**LIDL GREAT BRITAIN LIMITED AND NORTHPORT
LOCHALINE LIMITED**

WORLD OF WATER AQUATICS, KINGS LANGLEY

3rd TRANSPORT TECHNICAL NOTE

**REPORT REF.
187011-R-15**

Drawing Title: SITE ACCESS ARRANGEMENT

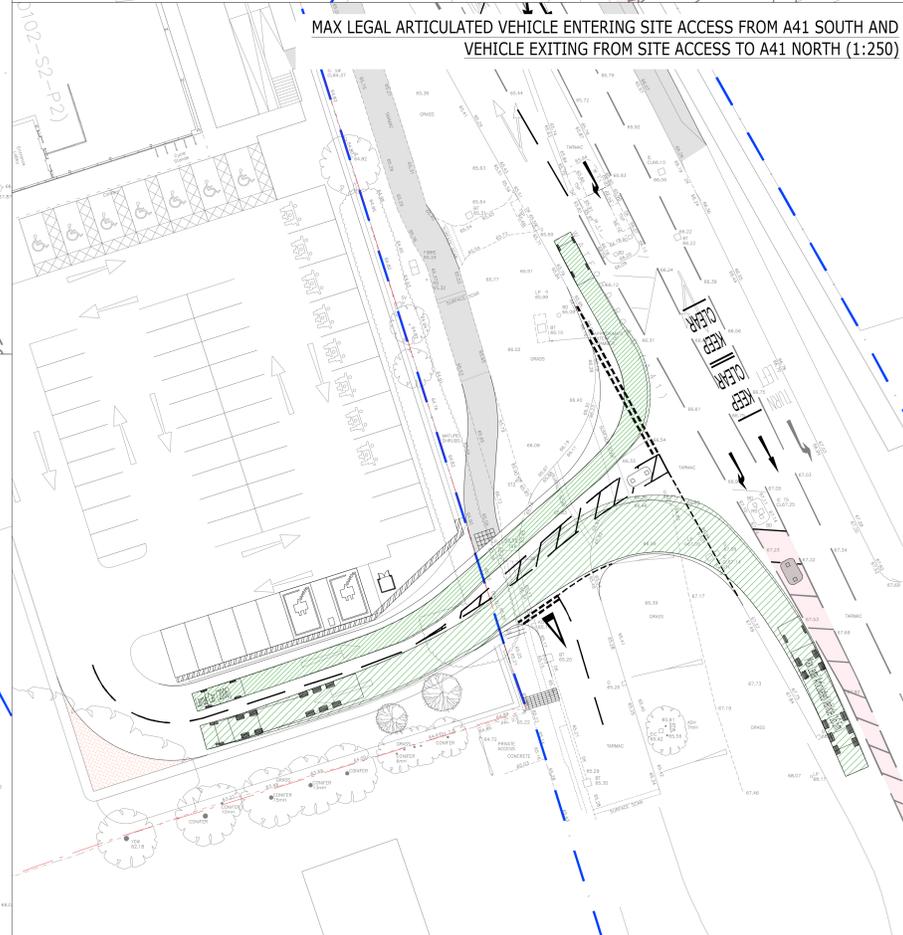
"The direct taper length for this right turn lane is proposed at 5m. While this meets the minimum requirements for a 30mph design speed (in accordance with the recorded vehicle speeds), it is less than the minimum requirements for a 40mph design speed. "

The direct taper length for this right turn lane is proposed at 5m. While this meets the minimum requirements for a 30mph design speed (in accordance with the recorded vehicle speeds), it is less than the minimum requirements for a 40mph design speed."

A preferable width of 3m between crossing limits is often recommended, allowing for cyclists to manoeuvre between the crossings on the island.

- 2.8 Notwithstanding the above, **ACE Drawing 187011-001J** has been updated to demonstrate how a 15m taper length could be provided (in line with CD 123 Table 5.22) for a 40mph speed limit, to alleviate the above concerns without significant impact on the proposed arrangement or requirement for additional modelling. The implementation of this increased direct taper would not have any significant impact on the proposed arrangement and should therefore not warrant refusal of the scheme. It is envisaged that this could be incorporated at detailed design stage, but the updated drawing included within this TTN should give confidence to the Committee that this can be delivered without significant impact on the overall operation of the junction.

2.62 In light of the above, **ACE Drawing 187011-001J** has been updated to demonstrate how a longer stagger of 1.8m on the island could be provided to ensure that cyclists could safely manoeuvre through the stagger. At this stage of the process, it is envisaged that this would be implemented and investigated further at detailed design stage. Though at this stage, should alleviate the concerns raised by the independent highways review by demonstrating that this minor amendment could be implemented if deemed as a requirement.

Drawing Title:
VERTICAL ALIGNMENT REVIEW

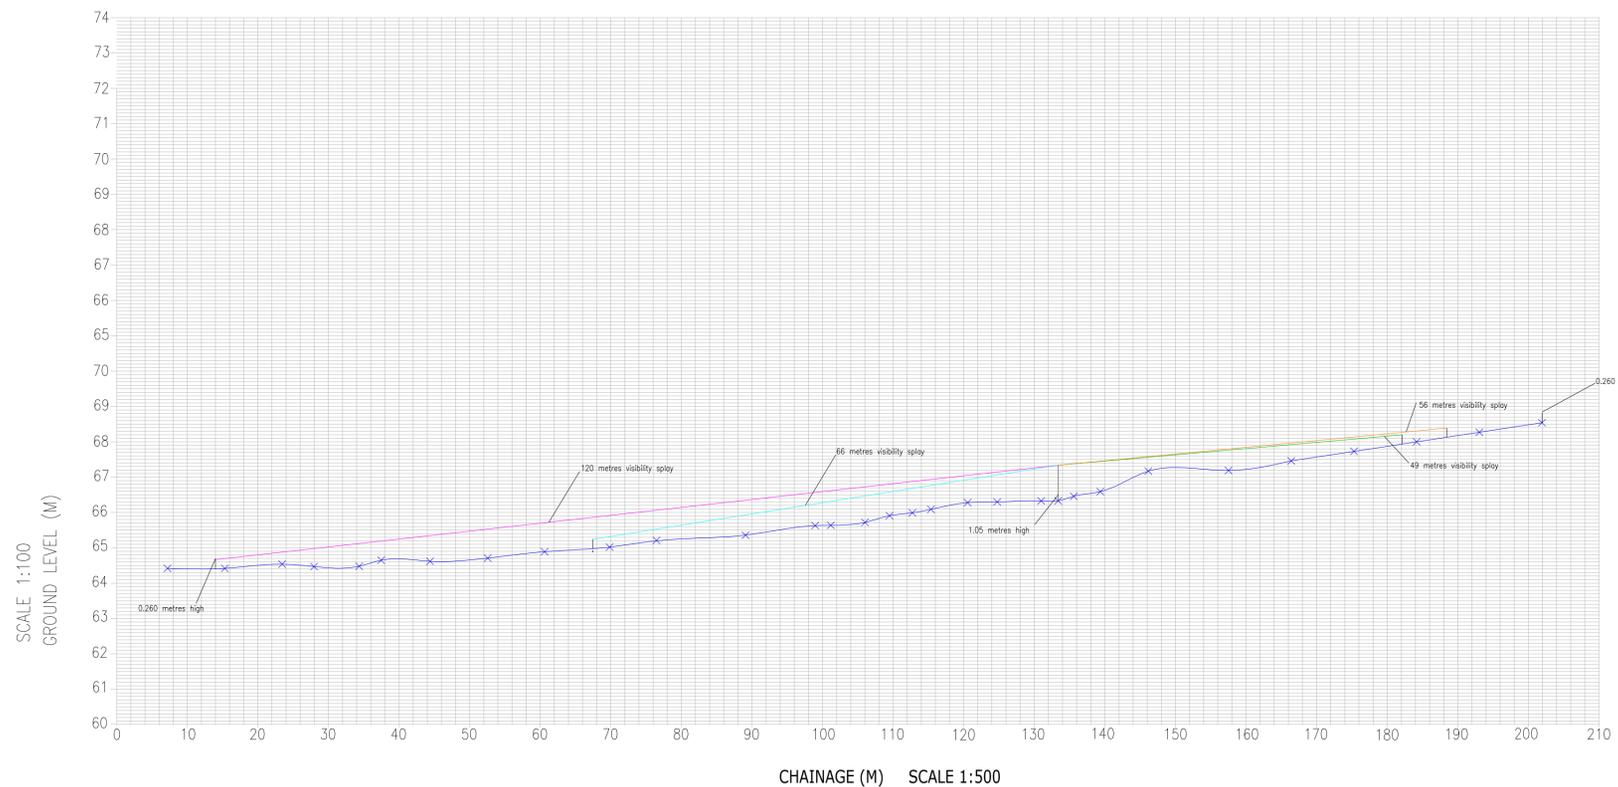
"Full details of the vertical alignment and levels have not been provided. However, this would be provided at the detailed design stages (which is a standard approach). We would suggest that the omittance of any level details at this stage should not be considered fundamental to the design principles. The level differences will need to be considered at the next stage, together with any supporting structures or earthworks required."

2.18 It should be stressed that a vertical alignment review was undertaken in relation to visibility as demonstrated in **ACE Drawing Number 187011-002D**. The drawing confirms that the calculated visibility splays can be achieved in the vertical alignment in line with the DMRB, taken to a object height of 260mm to the circulatory carriageway of the roundabout.

2.19 It can be confirmed that a full vertical alignment and levels review will be undertaken as part of the detailed design stage. However, the assessment undertaken demonstrates that visibility can be achieved in the vertical alignment.

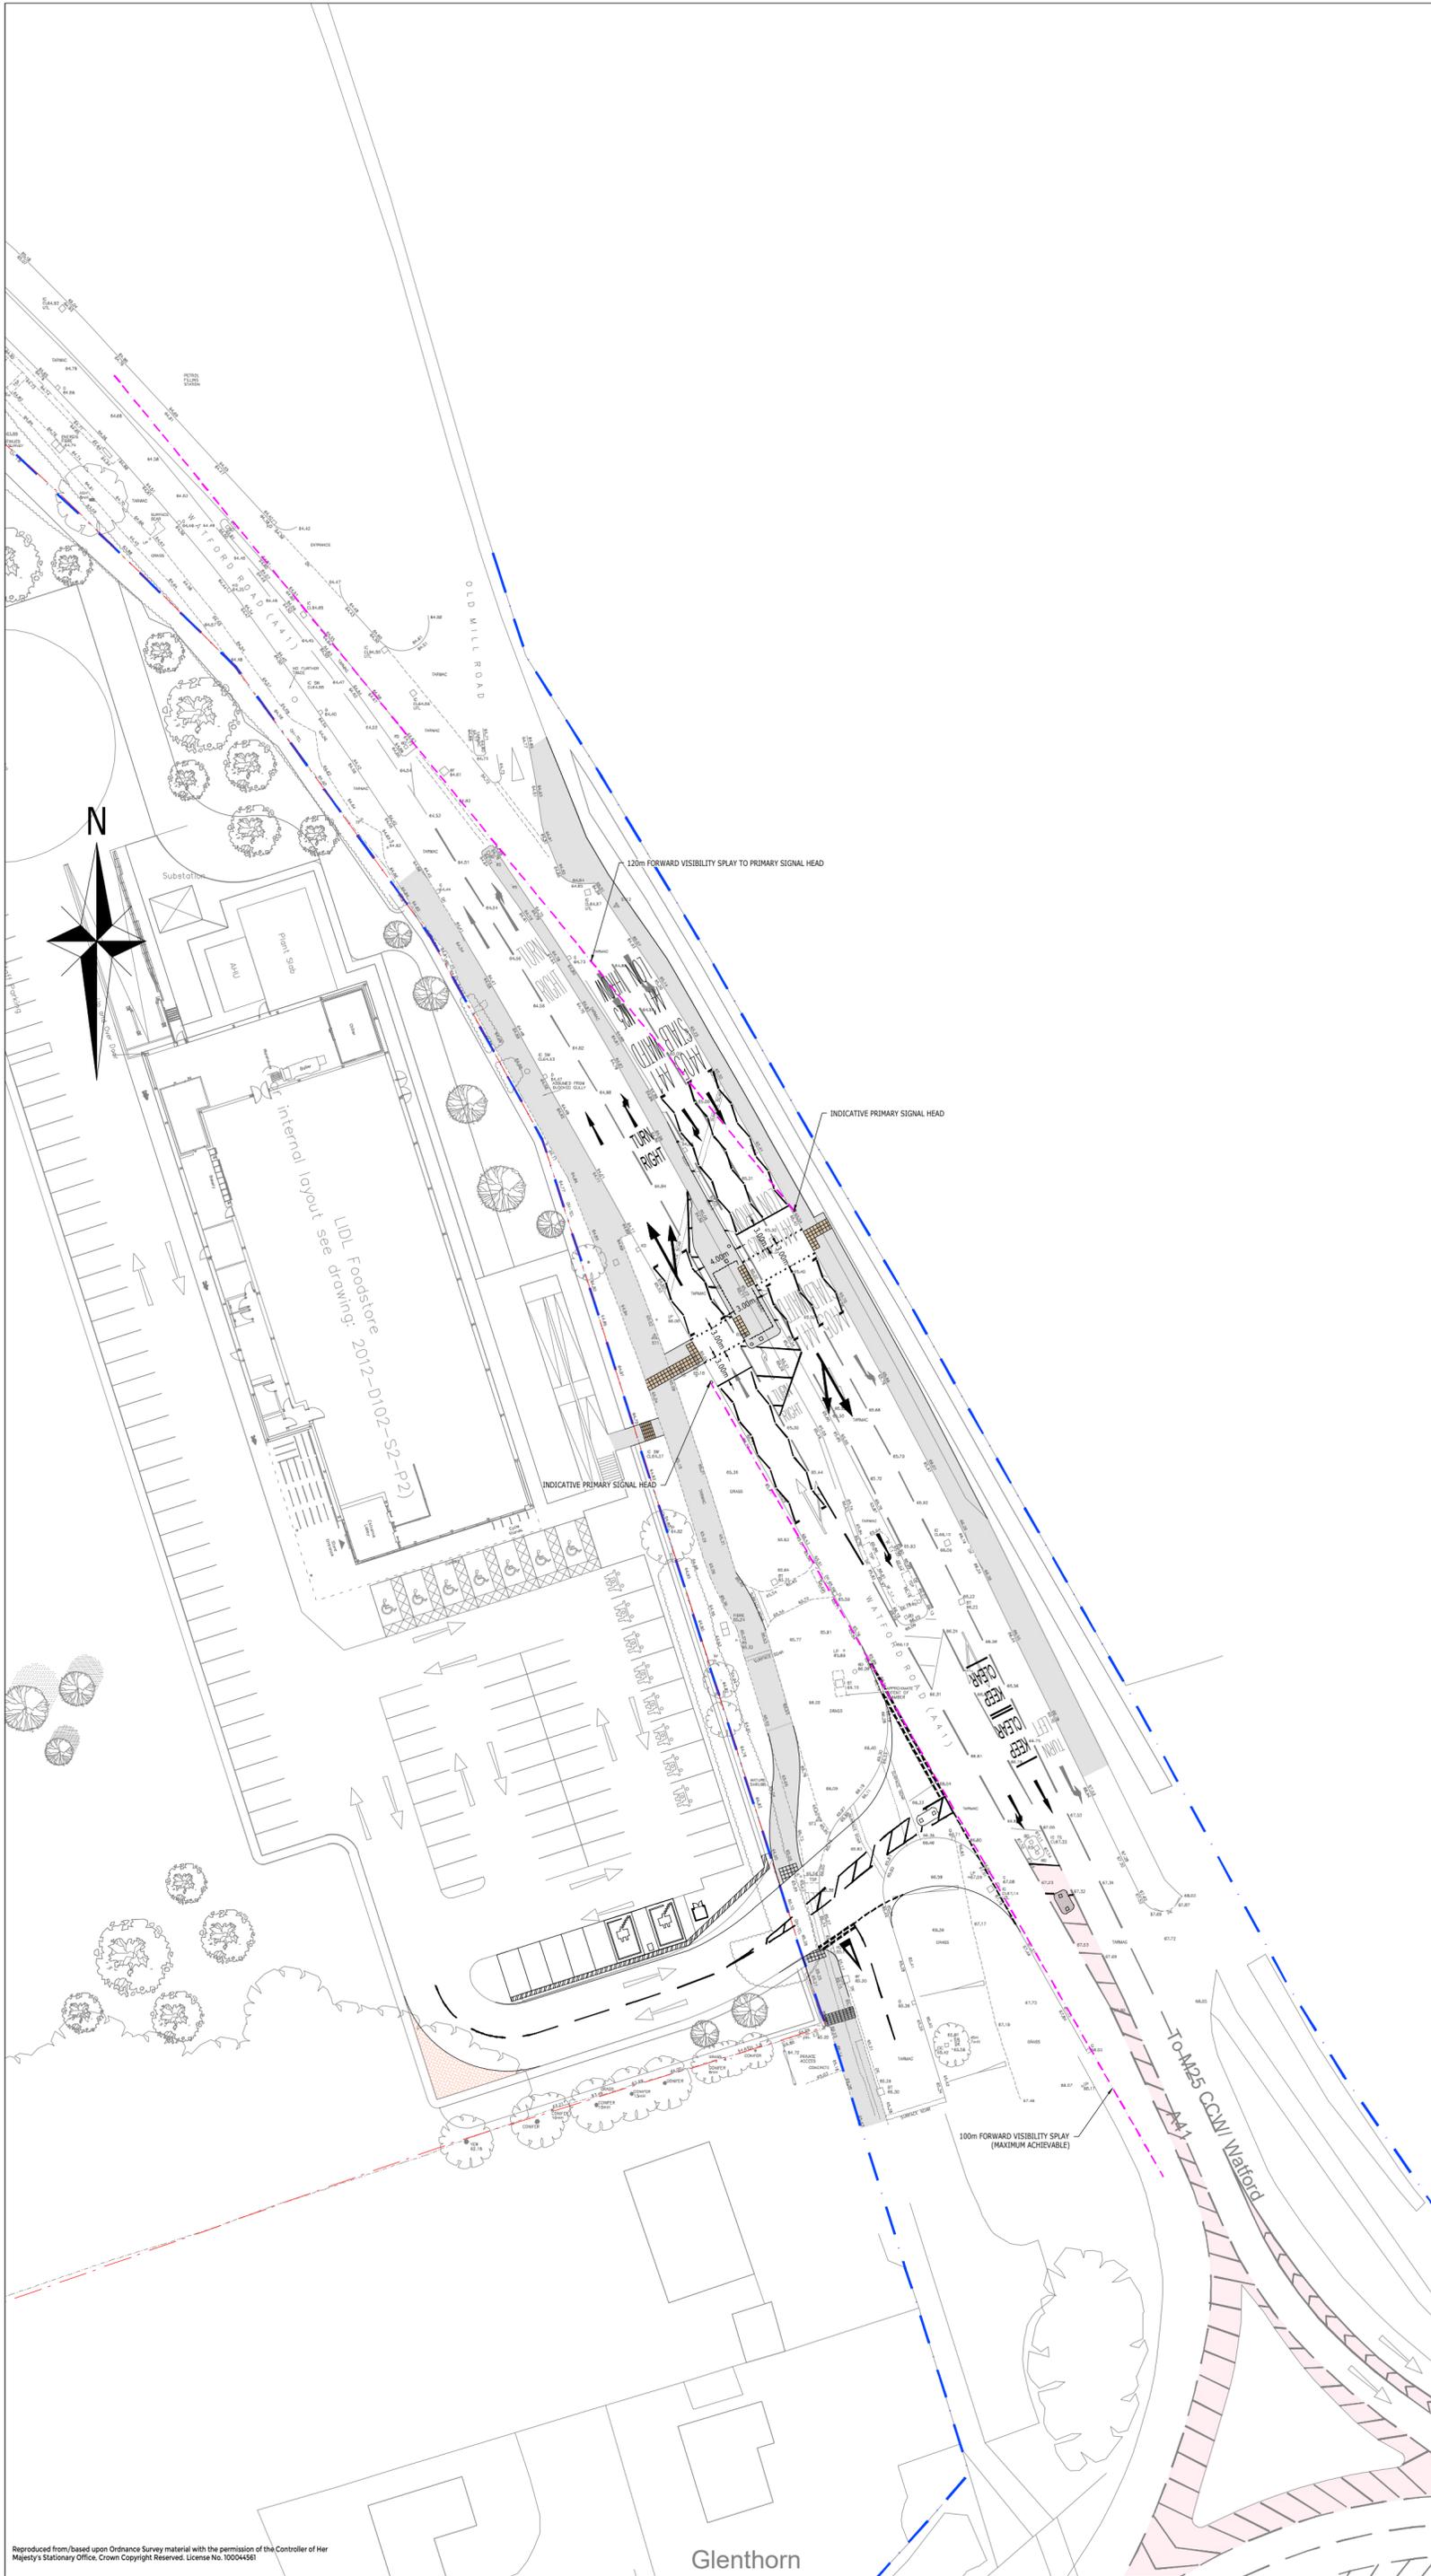
Whilst no forward visibility has been shown to the signal heads on drawing 187011-SK07 Rev A, the supporting report 'Transport Statement Addendum 187011-R-11 July 2023' makes reference to an additional drawing (187011-SK08) which was produced to demonstrate forward visibility to the signal heads.

2.63 This is noted. **ACE Drawing 187011-SK08** has been appended to this report for completeness.

APPENDIX A – DESIGN REVIEW WITH REPORT REFERENCES

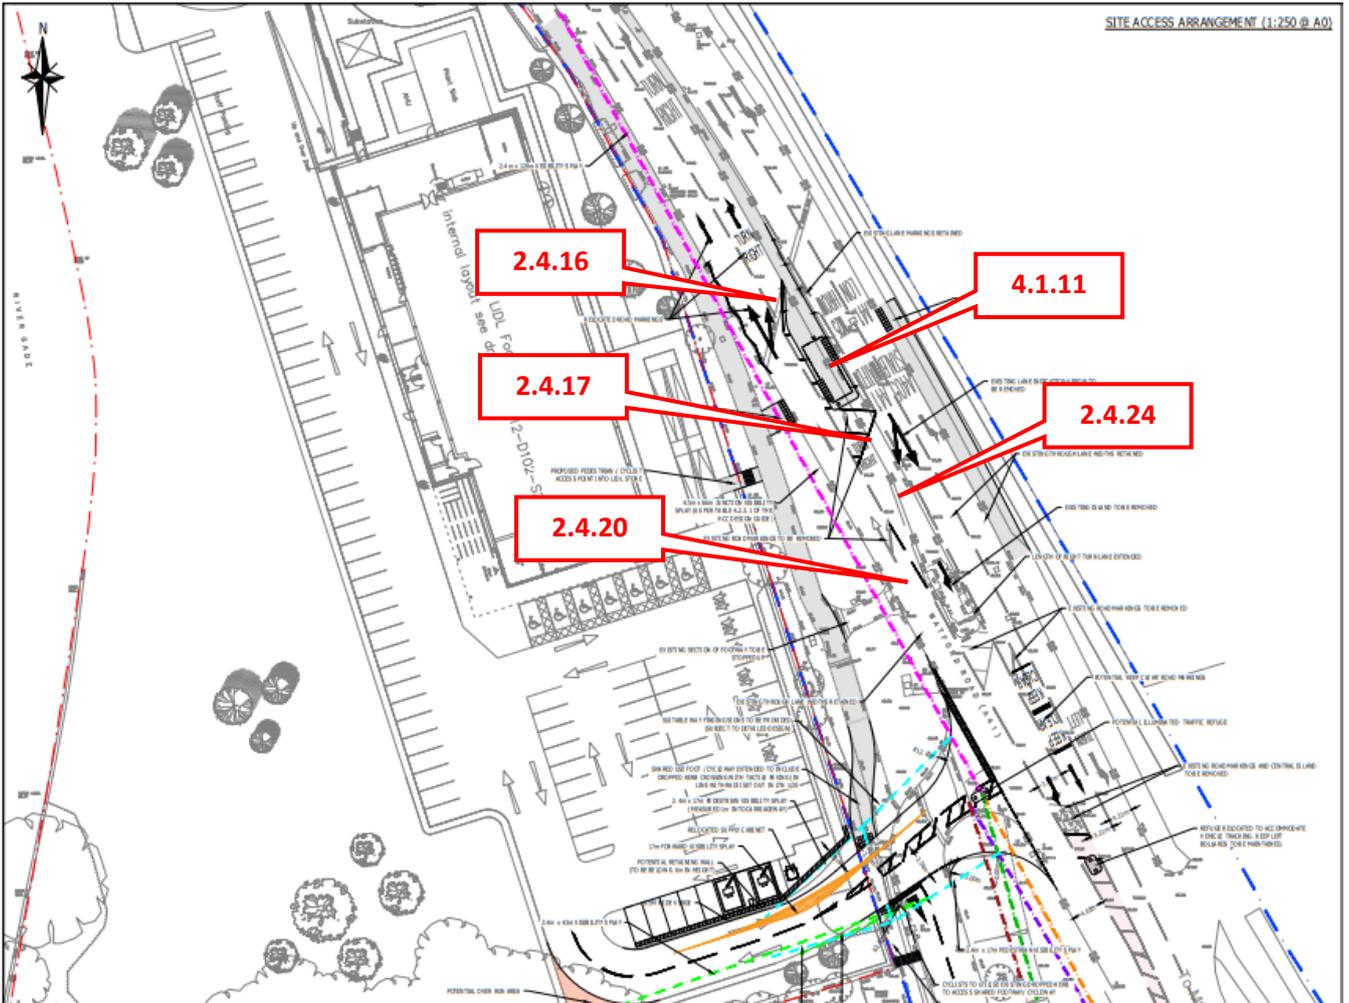
- 2.2.4. Design issues raised within the site review have been shown on the plan in **Appendix A** with reference to their applicable paragraph numbers from within this highway review document.
